Technical Note

Project: Chichester town centre: cycle review of proposals

Subject: Alternative Approach

Client:	CLlr Sarah Sharp, Chichester South	Version:	1
Code:	02515	Author:	LM
Date:	3 December 2016	Approved:	AL

Figure 9: Sketch idea 2, Westgate/Orchard St junction – linking existing cycle route

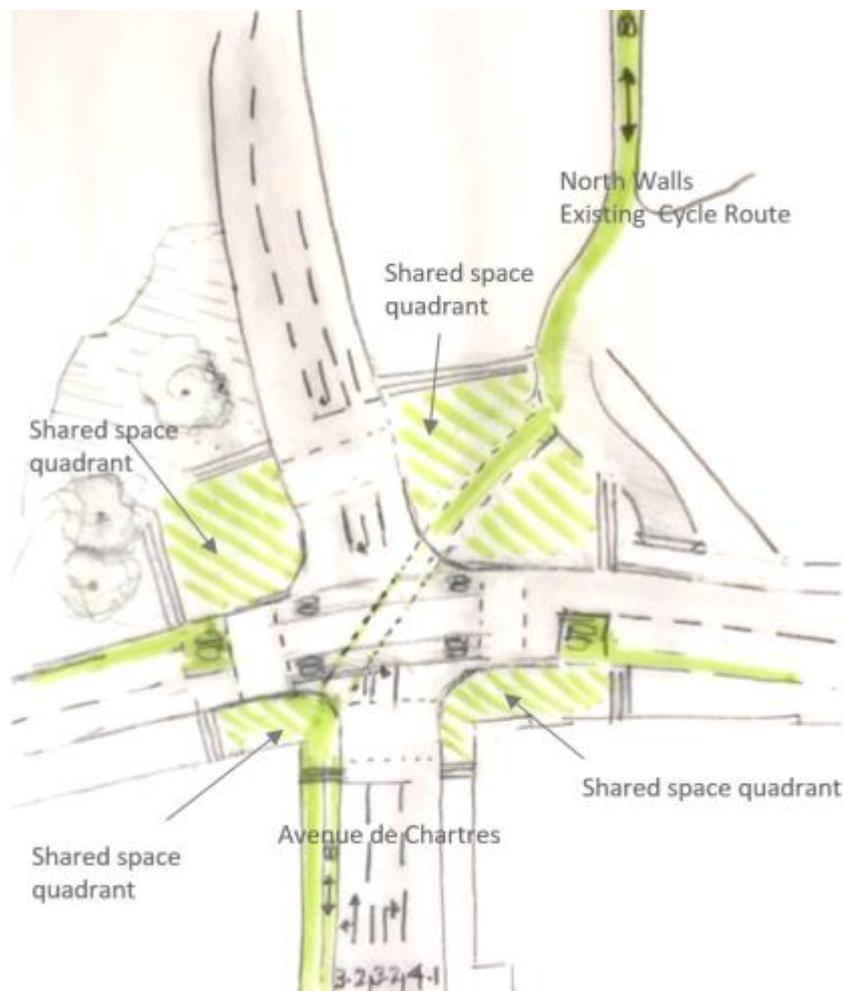
- 3.14 This section outlines a less radical redesign with some minor design amendments. Avenue de Chartres and Orchard Street form part of the Chichester Ring Road and as such relatively heavy volumes of motor vehicle are to be expected. Therefore, arguably, these roads are unlikely to be attractive environments in which to cycle without further infrastructure improvements along each link as well as at the junction.

- 3.15 To address the most useful north-south movement for cycle traffic, it is noted that Avenue de Chartres has a shared cycleway footway on its west side, albeit of intermittent quality with one section where those cycling are required to dismount. With minimal work, the path west of Avenue Chartres – which continues to the station, Westgate Leisure Centre and other important trip attractors – could form a key part of a Chichester cycling network if access to this route were more convenient and clearly demarcated. Therefore, the junction layout should facilitate cycle traffic wanting to access the cycleway on the west side of Avenue de Chartres.

- 3.16 The current division of space south of the junction could be altered to allow a two-way track on the south-west of the junction. Traffic lanes on the approach to the junction are wider than the 3.2m standard lane width set out in Manual for Streets. By reducing proposed queuing lane

widths to 3.2m, a better environment for pedestrians and cycle traffic can be achieved without loss to motor traffic capacity.

- 3.17 The dismount section of Avenue de Chartres, south of the junction, could be removed by altering the configuration of the bus stop by making use of the space available mid-carriageway which is currently hatched out adjacent to a central reservation. The traffic lane can be moved over to fill this currently unused space, and the bus stop built out to create a wider footway around the bus stop. This may be sufficient to provide a separate cross-section for cycle traffic – as opposed to shared use at present either side of the bus stop – a configuration that has been successfully in place in Brighton since 2013, and known as a ‘bus stop bypass’ or ‘floating bus stop’.

- 3.18 In the other direction along the north-south axis through the junction, the city walls provide an alternative orbital route for cycle traffic parallel to Orchard Street, both at ground level (officially) and informally at the elevated level. Therefore, it is recommended that the signalised junction facilitates diagonal movement for cycle traffic between Avenue de Chartres (west side) and Wall Cottage Gardens. This can be in the form of a diagonal cycle crossing stage during the all-red pedestrian phase. A short cycle link from Wall Cottage Gardens can make the presence of this route clear. The quadrants of the junction would act as shared use as cycle traffic would be moving slowly at this node point.

- 3.19 For west-east movement, taking cycle traffic off the carriageway and then back on again results again in additional conflict with motor traffic and pedestrians. Cycle traffic also loses priority over side road traffic at Wall Cottage Gardens, and cycle traffic will have already had to wait for a full cycle of the junction in order to make use of the all-red phase. However, cyclists remaining in the carriageway benefit from the same amount of green time as motor traffic, plus they retain priority at Wall Cottage Gardens. It is therefore recommended that the off-carriageway cycle lanes are removed and replaced with advisory cycle lane markings through the junction.

- 3.20 These should be located away from the nearside of the mixed traffic lane – i.e. at least 1m from the kerb – to avoid cycle traffic being led into the nearside “left hook conflict” location, where risk of collision with turning vehicles is greater. With the quadrants of the junction available as shared use (for pedestrians and cyclists), dropped kerbs should be provided to facilitate access to these areas so that cyclists wishing to pass through the junction without traffic moving can do so during the pedestrian stage. This would also facilitate right-turning movements for cycle traffic.

- 3.21 The footway should also be continued across the mouth of Wall Cottage Gardens to indicate pedestrian priority. The tightening of the junction should be investigated in order to shorten pedestrian and cycle crossing distances. This may have the benefit of reducing inter-green times and thus improving junction capacity. Tightened junctions also lead to fewer and less serious casualties because they oblige drivers to undertake turns at lower speeds, which means road users have more time to see each other and react accordingly.

Figure 10: Proposals for Westgate. Source: Extract from Vectos Plans

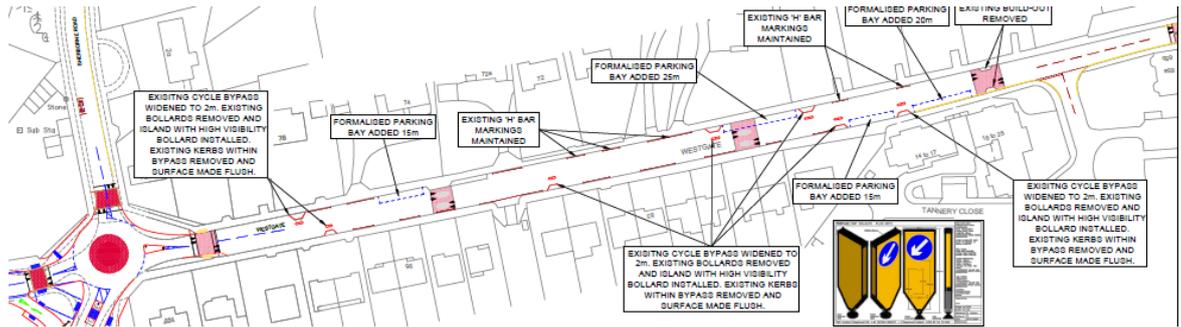
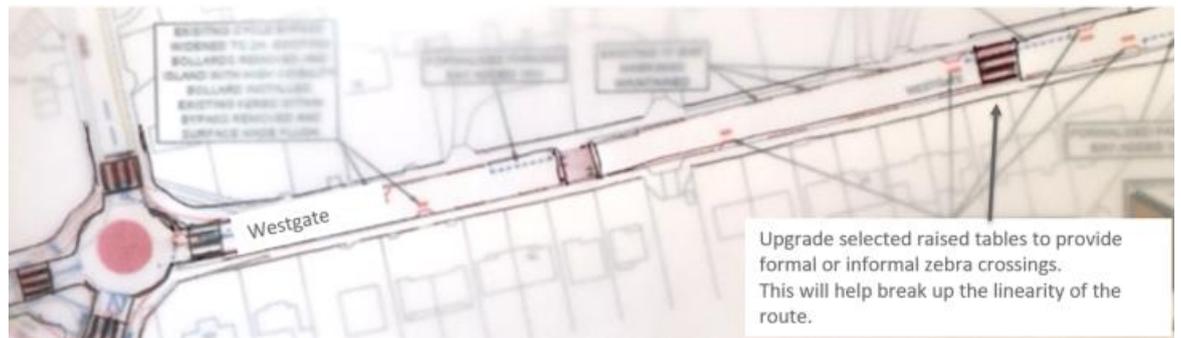
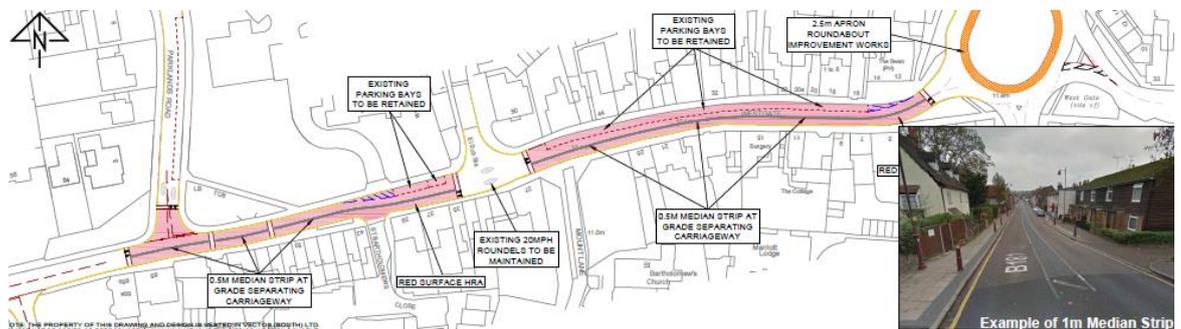
- 4.2 Westgate is divided into two distinct character sections: We present recommendations consistent with the respective typologies. In the eastern section, Westgate currently benefits from being relatively uncluttered with no centre line, few paint markings, minimal highways engineering clutter – all factors which help keep the space simple and legible.

- 4.3 It is unclear what benefit the median strip and surface overlay would provide. The proposed surface overlay and median strip appears to be detrimental to the historic character of the street. A median strip also introduces a visual demarcation between opposing traffic flows, and TfL research has found that the absence of median demarcation reduces vehicle speeds⁴ (so the median strip could potentially lead to increased speeds). It should be noted that new, smooth road surfaces generally result in higher traffic speeds. Also, the width of the median strip – 0.5m – provides little benefit to pedestrians if the intention is to allow two-stage crossing movements. If the idea is that the median strip will assist with crossing, and that there is a desire to cross the road in places (which inevitably there will be) it is better to provide crossing points where motorists are obliged to stop and give-way, by using zebra crossings or indicative zebras.

- 4.4 In both sections of Westgate, we recommend that some of the raised table traffic calming features are upgraded to pedestrian crossings: either with formal zebra crossing markings or with contrasting materials (see Figure 22) that encourage drivers to cede to pedestrians wanting to cross (and are therefore more beneficial to pedestrians than a raised table alone).

- 4.5 The hatching around the parking bays is a further visual intrusion into this attractive street. A more sensitive approach might be to use ground-mounted planters, with suitable reflectors, to act as ‘bookends’ for the parking bays. These are more effective than hatching as they are in situ at all times, whereas when the parking is not occupied, motorists can easily encroach into the hatching removing its effectiveness.

- 4.6 The side roads along Westgate do not have a consistent treatment. Mount Lane has a continuous footway across the mouth of the junction with Westgate giving visual priority to pedestrians (see Figure 14). However, adjacent junction mouths are wider, which can be difficult for vulnerable pedestrians to use. It is recommended that the continuous footway treatment at Mount Lane is replicated at the other side road junctions off Westgate to provide a consistent environment with a better level of service for pedestrians. Continuous footways slow vehicles

Figure 17: Proposals for Westgate/Sherborne mini roundabout. Source: Extract from Vectos Plans

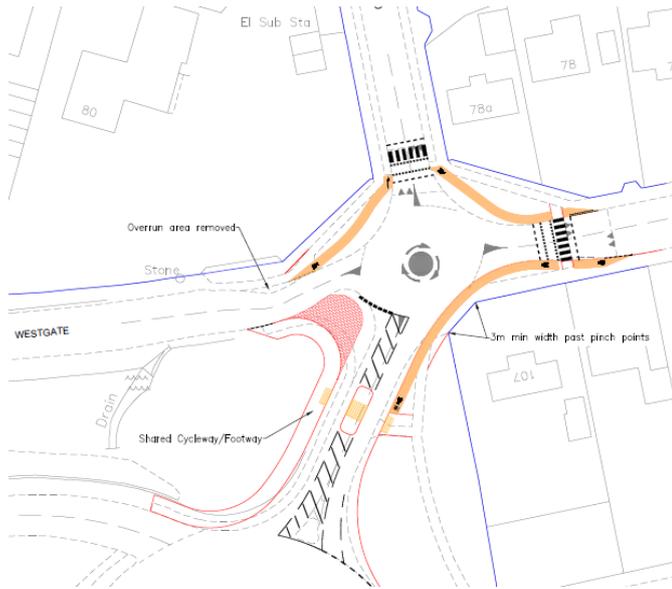
- 5.2 It should be noted that the design above differs from the treatment shown in the proposed Westgate improvement scheme drawings. The commentary below relates to the above proposals only. However, we will make passing reference to the other layout where relevant, and this will be clearly stated.

- 5.3 The existing layout is hampered by the overrun area required for buses to turn left into the stub-end section of Westgate, and it is acknowledged that this is a detriment to pedestrians because it widens the space they have to cross. It is unclear why the proposed left-slip lane has been abandoned from the proposals (as shown in the Westgate scheme drawings) since the inclusion of the left-slip lane would allow a tighter geometry and pedestrian/cycle crossing to be more easily integrated to the south of the roundabout.

- 5.4 Widening the road to the south of the roundabout opens up the road and separates the traffic – both features which are shown to increase driving speeds and are likely to make the roundabout and the road less conducive to walking and cycling.

- 5.5 The proposed cycle lanes are useful for left-turning movements, but all other movements at the junction are made more problematic with this arrangement. Some cycle traffic may remain on carriageway to turn right or carry on ahead, and motorists may incorrectly perceive that a cyclist is wrong to stay on the carriageway: this may lead to aggressive or bullying behaviour.

Figure 18: Sketch idea 1: Minor alterations to align the cycle route

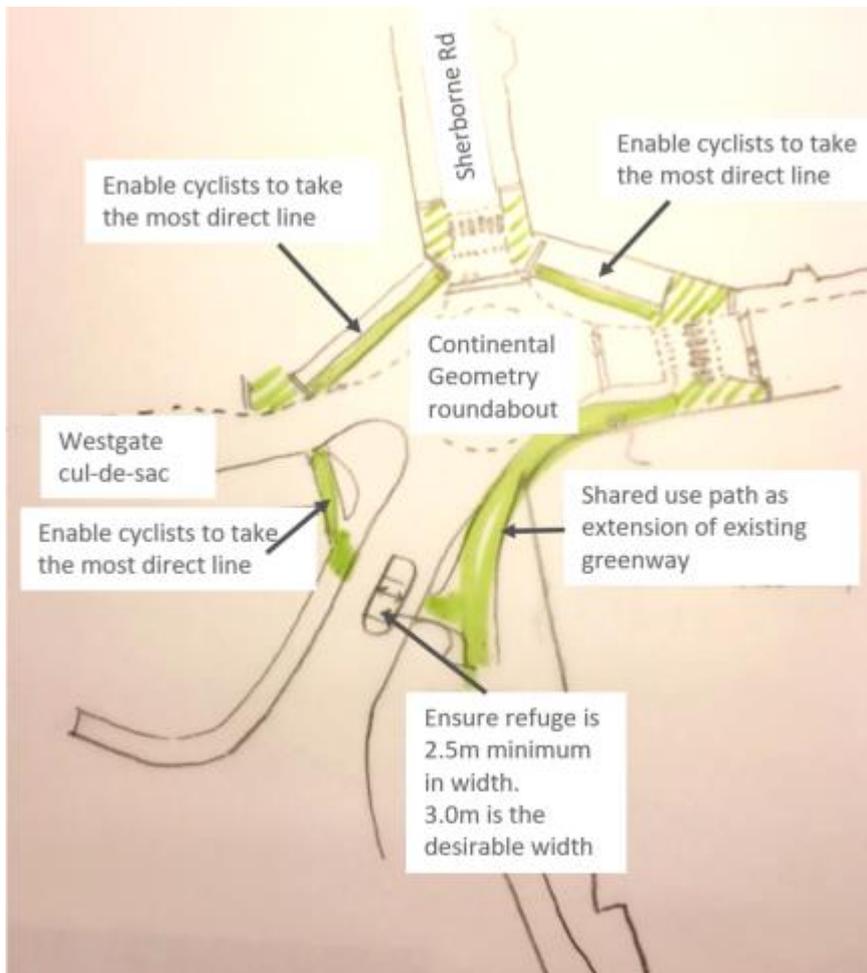
- 5.6 A more legible approach would be for the cycle facilities to operate two-way around the junction so turning movements can avoid the roundabout completely. Because of constrained spaced, it

is recommended the south-eastern quadrant of the junction is shared use, consistent with the greenway that connects to the south. The alignment of the paths can also be amended to avoid cycle traffic being required to make a sharp 90-degree turns. Finally, the path on the south-west quadrant of the junction should connect directly between the two crossing points, rather than following the long way around parallel to the kerb. This will improve visibility as pedestrians and cyclists will arrive at the crossing point largely perpendicular to the kerb, rather than having traffic approach the conflict point from behind them.

Figure 19: Sketch idea 2: three parallel crossings plus gateway feature

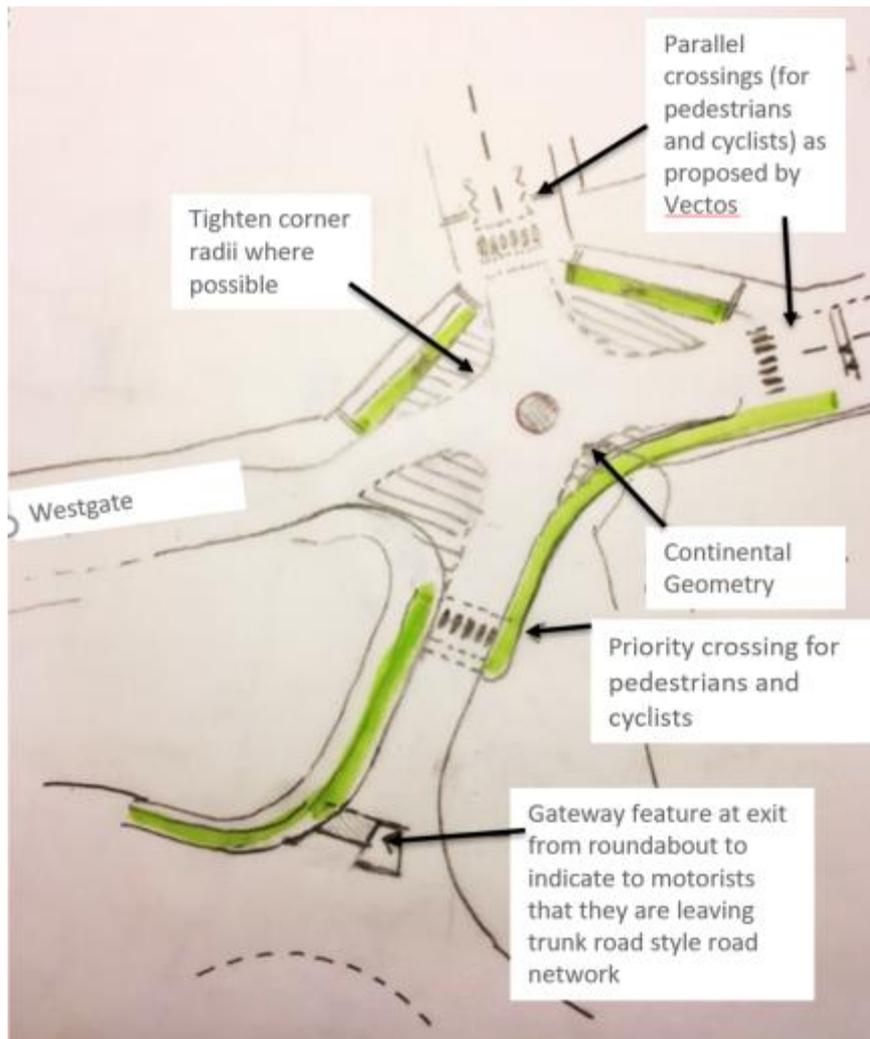
- 5.7 A third parallel crossing should be considered for the arm to the south of the roundabout. A gateway feature could be introduced at the splitter island on the exit from the large roundabout to the south, then motorists can be fore-warned that they are entering a lower speed environment (if the road is not widened).

Figure 20: Sketch idea 3: continental geometry with parallel crossings. We do not have traffic flow and modelling information or survey to provide a detailed alternative proposal.

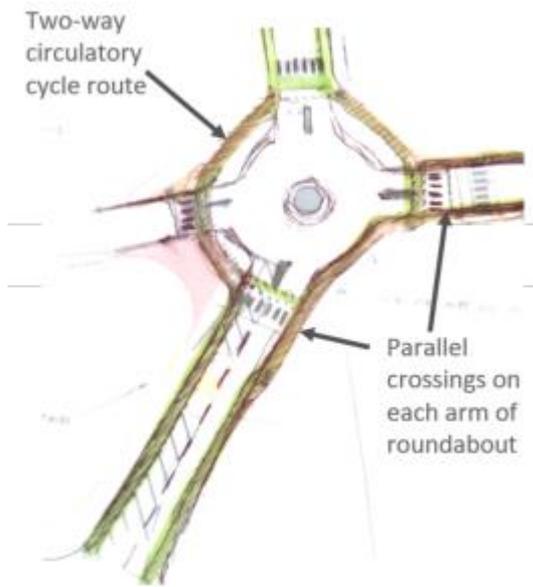
- 5.8 The Vectos plans include three different crossing types within a single roundabout site (Sherborne/Westgate). The roundabout design could be simplified by creating parallel crossings on each of the four arms of the roundabout rather than different crossing types on each arm. See the Cambridge roundabout proposal (Figure: 21) by way of example. Motorists are not obliged to give way to people crossing at pedestrian refuges or splitter islands, so crossings would also improve accessibility particularly for vulnerable road users such as older people who benefit from the legal priority provided by a zebra crossing.

- 5.9 Creating a compact continental geometry would reduce speeds and casualties. Principles include removing splitter islands or using pellet shaped splitter islands (rather than flared islands) to slow turning movements, removing central hatching, tightening flares and the circulatory lane.

- 5.10 Further, segregated cycle facilities on the approach to each parallel crossing would provide a facility which can be used by all ages.

Figure 23: St. Paul's Road Right Hand Turn Lane. Source: Extract from Vectos plans

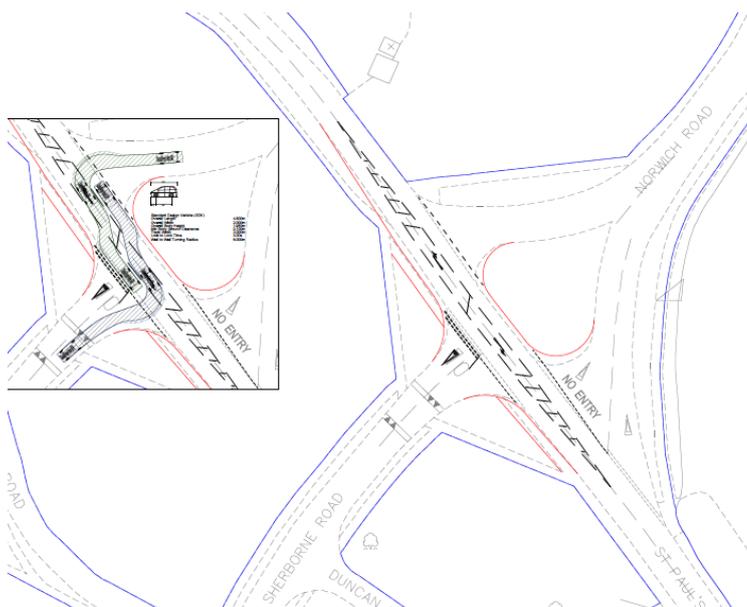
- 7.1 The four-arm junction of St Paul’s Road, Sherborne Road and Norwich Road is an unusual layout. It appears that right-turn pockets have been proposed to accommodate additional volumes of traffic travelling from the new development (to the north) towards the A27 via Sherborne Road.

- 7.2 There are no desire-line crossings provided for pedestrians, and cycle traffic carrying out a crossing manoeuvre or right-turn will find itself in a vulnerable position, both with the current layout and in the proposal.

- 7.3 The generous curvature of the Norwich Road junction will encourage fast turning manoeuvres, which can lead to elevated collision risk for cycle traffic.

- 7.5 The proposed footway adjacent to St Paul’s Road leads pedestrians to a very uncomfortable crossing point where traffic is turning in to the side road from behind them. The existing raised table a short way into Sherborne Road is recommended as a much more natural and comfortable crossing point, and as such the layout of pedestrian infrastructure should reflect this.

Figure 24: St. Paul’s Road Right Hand Turn Lane – sketch idea

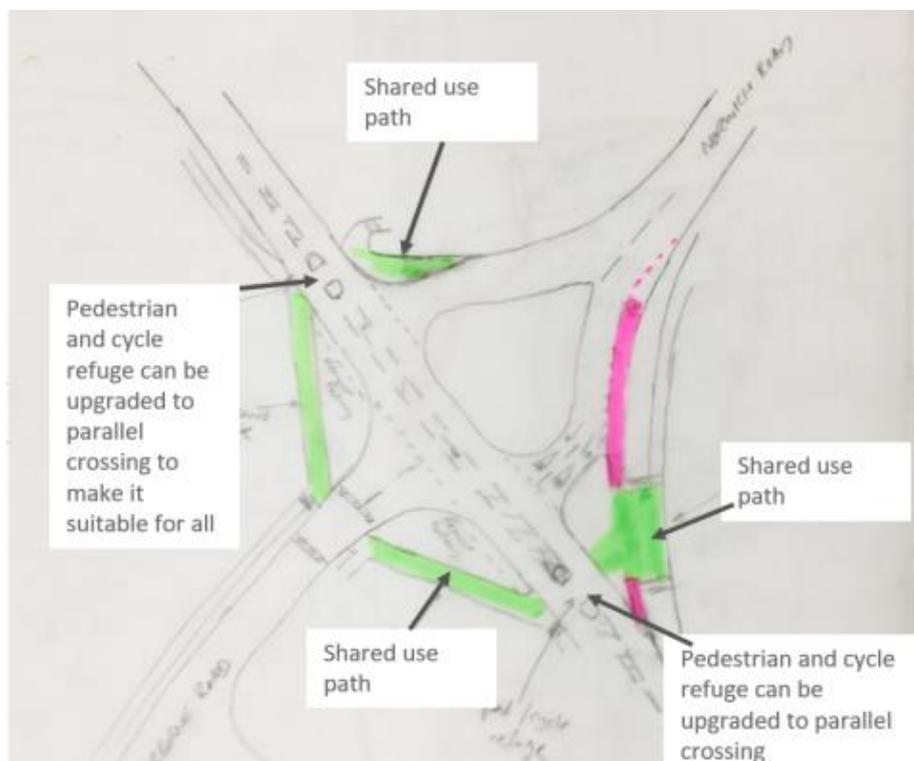
- 7.4 All these issues can be addressed by reducing the entry and exit geometry on Norwich Road and using the space gained to provide pedestrian crossings. These can be tied in with widened footways to accommodate a short section of shared use, as a feeder link for cycle traffic. A left-turn by-pass slip can be provided for cycle traffic exiting Norwich Road.

- 7.6 All crossing points – existing and suggested – could take the form of parallel pedestrian-cycle Zebra crossings, to provide vulnerable pedestrian and cycle traffic with legal priority. These may also act as a useful gateway feature for southbound traffic as it enters the urban area.
